Subject: Replacement Steam Generators

San Onofre Nuclear Generating Station, Unit 2 & 3

Ref: Your letter dated November 30, 2004

Figure 3. Typical AVB design by MHI

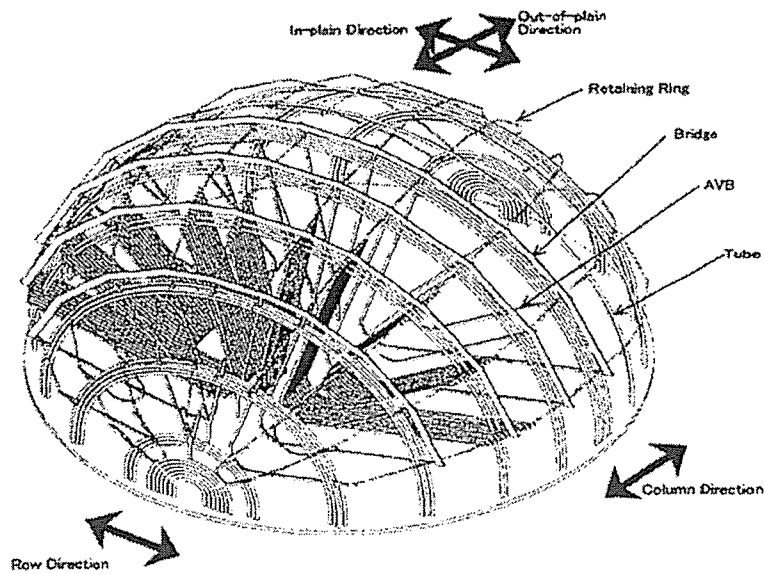
Anti-Vibration Bar (AVB) design is one of the most critical design issues in the SONGS RSG design. We are aware of recent US experience of tube wear in the AVB design in large size replacement steam generators. We understand that it is a very important area for design and fabrication which we will carefully address. Edison and MHI mutually agreed to review available data related to the cause of the tube wear event. We will modify and improve our AVB design from our conventional design developed for smaller RSGs than SONGS, based on this review result. A typical AVB design is shown in Figure 3. V-shape AVB bars are inserted to prevent fluid induced vibration (fluid-elastic instability) during operation. The engineering schedule for AVB design is shown in Table 2.

Fabrication of AVBs will start from January 2006. Before that we will study previous MHI design and fabrication experience, which utilized a similar tube specification and tube manufacturer (). We will also get the critical dimensional and tolerance data of SONGS specific tubing through the PPQ (Pre-Production Qualification test) process, which will start in June 2005. PPQ test results will allow MHI to confirm the adequacy of the design for the SONGS AVBs. The verification procedure as well as design concept itself will be discussed with Edison's Design Team in the coming few weeks.
